**CITY OF BOULDER
CITY COUNCIL AGENDA ITEM**

MEETING DATE: March 1, 2022

Consideration of a motion to amend the Transit Village Area Plan Streetscape Guideline for 30th Street to remove on-street parking and to replace trees in grates with an eight-foot-wide streetscape planting strip and 10-foot-wide detached sidewalk and protected bike lanes per the Transportation Master Plan, including text amendments as provided in the staff memo.

Figure 5: PROPOSED
30th Street Cross-Section Guideline for TVAP

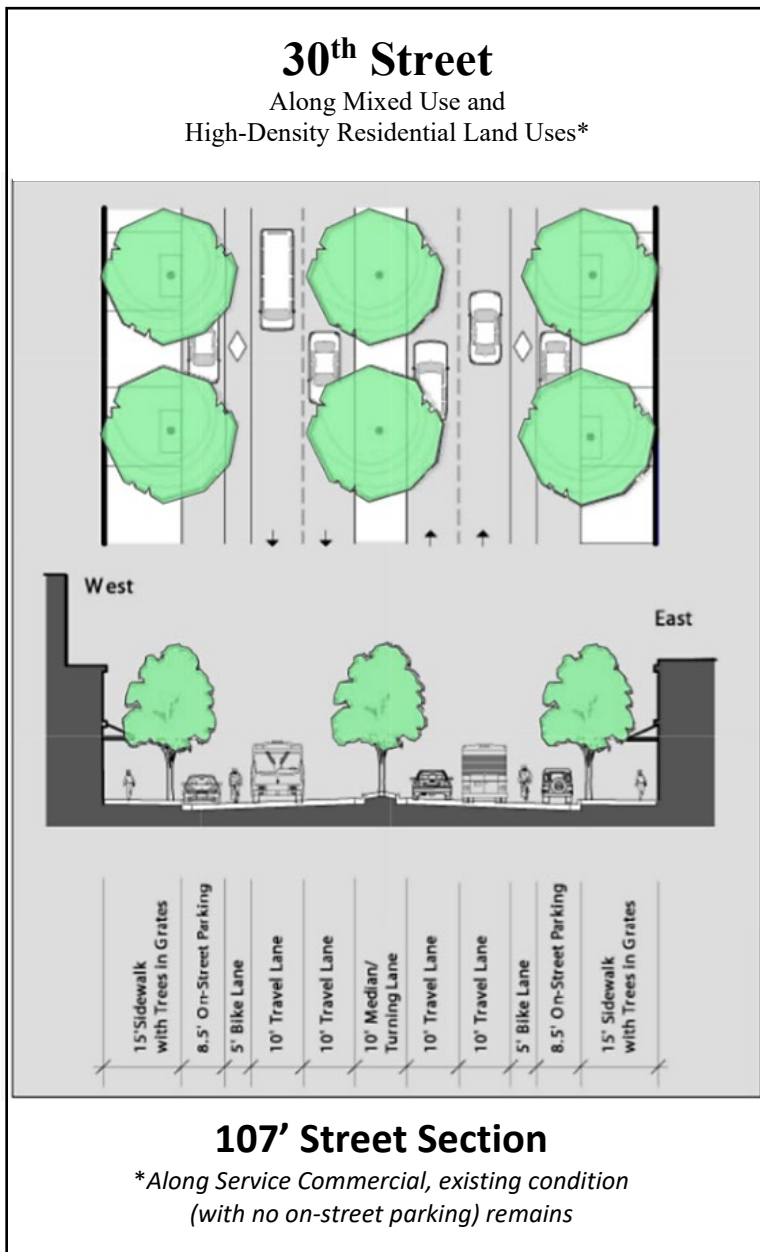
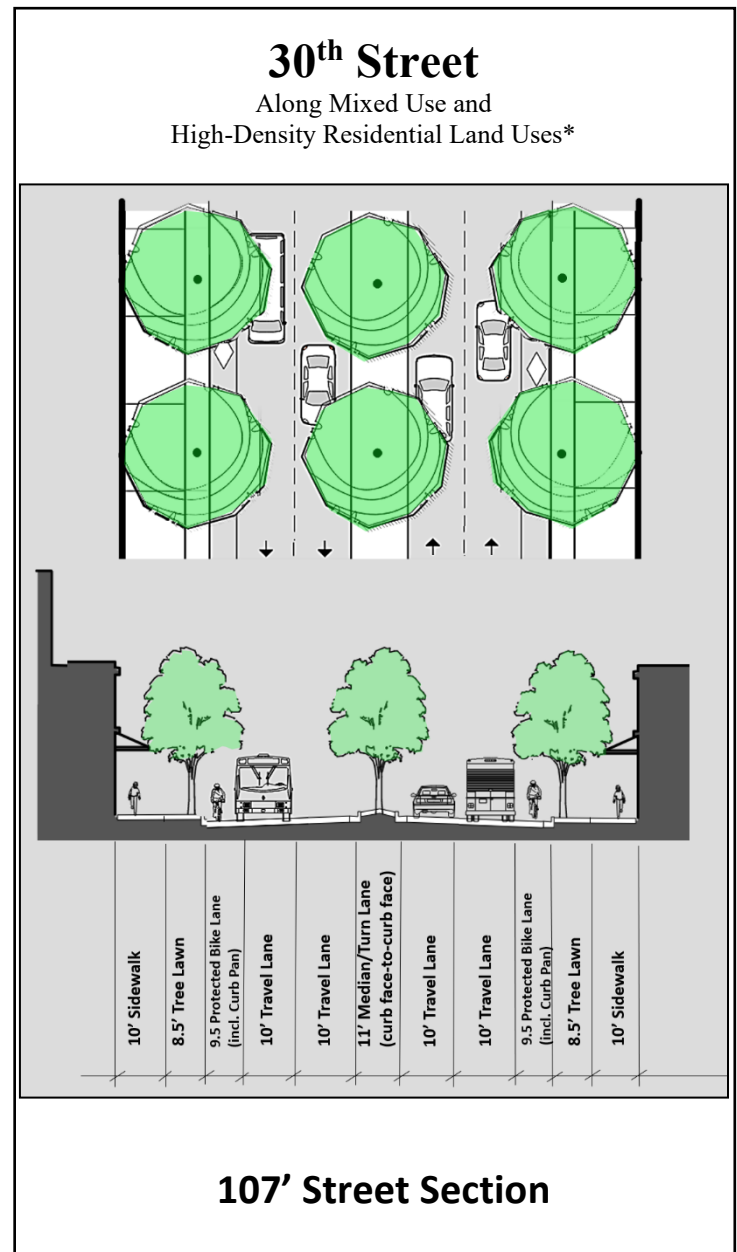
Staff recommends that the TVAP – Streetscape Guidelines for the cross section for 30th Street be amended to remove the on-street parking element of the section. In addition, staff recommends that the street trees shown in tree grates in a 15-foot sidewalk instead be planned within an eight-foot planting strip area with a detached 10 foot walk. Figure 4 on the following page, illustrates the existing streetscape guideline and Figure 5 illustrates the proposed 30th Street cross-section.

The revised cross-section for 30th Street also proposes to remove the trees in grates which are an appropriate streetscape design element to support on-street parking in a downtown or parking district area, but not in the proposed cross section. The trees in grates are proposed to be replaced with an eight-foot-wide streetscape planting strip. This would result in a streetscape section along

The revised cross section applies to 30th Street from the Boulder Slough crossing to Valmont. It is not intended to apply along services commercial where existing conditions are intended to remain. In addition, staff recommends that the text that accompanies the existing cross-section at the bottom of page 35 of TVAP be deleted as it references on-street parking.

30th Street consisting of a ten-foot-wide detached sidewalk separated from 30th Street with an eight-foot wide planting strip and a protected bike lane as part of the roadway.
